OXY USA Inc. - Sterling Silver MDP1 33-4 Fed Com 1H, 2H, 3H, 4H, 5H, 6H, 7H

This is a bulk sundry request for 7 wells on 3 pads. The wells related to this sundry request are:

Oxy respectfully requests approval for the following changes from the approved permit:

13-5/8 3M SACR + 13-5/8 MNDS 5x10 Slips (9.625 x 7.625 x 5.5)

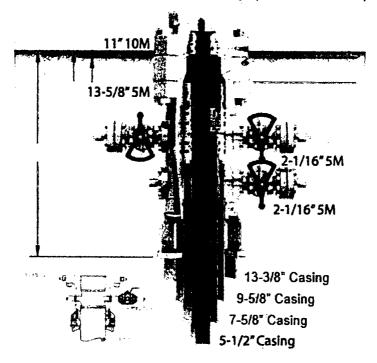
1. Change to the wellhead design

Due to the casing design change and adding another casing string to the well, a 13-3/8" 3M sacrificial wellhead will be used to drill the 12-1/4" Intermediate Hole. Upon completion of drilling and cementing operations on the 12-1/4" Intermediate Hole section (along with proper WOC time), the wellhead will be cut off. At this point, the 13" 5x10 MNDS, be welded onto the 9-5/8" casing for the remainder of drilling operations on the pad.
